SERVICE BULLETIN No.1143

COACH MODEL	: T2145 and C2045 (except coaches w/ multiplex)
BULLETIN TYPE	: Product Improvement
MANUAL & SECTION	: Maintenance Manual: Chapter 5 - Brakes Spare Parts Manual: Section 782009 – Electrical equipment
PARTS BOOK REVISION	: Yes
DATE	: September 15, 2004
SUBJECT	: Brake pad wear indicator relay – parts change
TERMS & CONDITIONS	: No claims will be accepted with reference to this Bulletin.

Figure 1: C2045 brake pad wear indicator relays (from left to right):

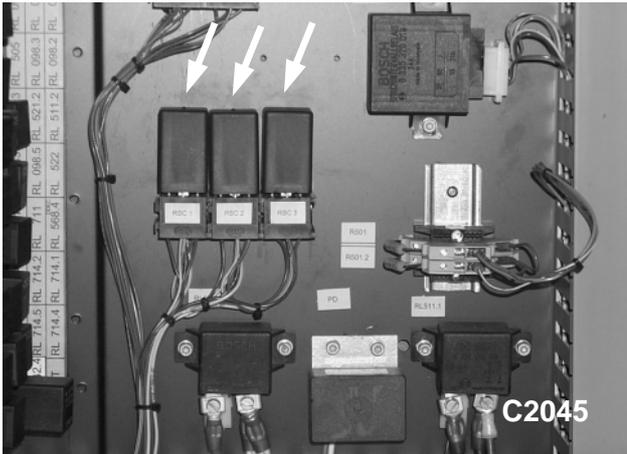
To improve the operation of the brake pad wear warning system, the wear sensor control units (relays), which are located in the basic electrics section of the main junction box, have been replaced by less sensitive items.
Refer to the parts section and Figures 1 and 2 overleaf for parts location and relevant part numbers.

Part No.	Description	Qty.
VH 660752065	Brake pad wear indicator relay	3

Part No.	Description	Qty.
VH 10727054	Brake pad wear indicator relay	3
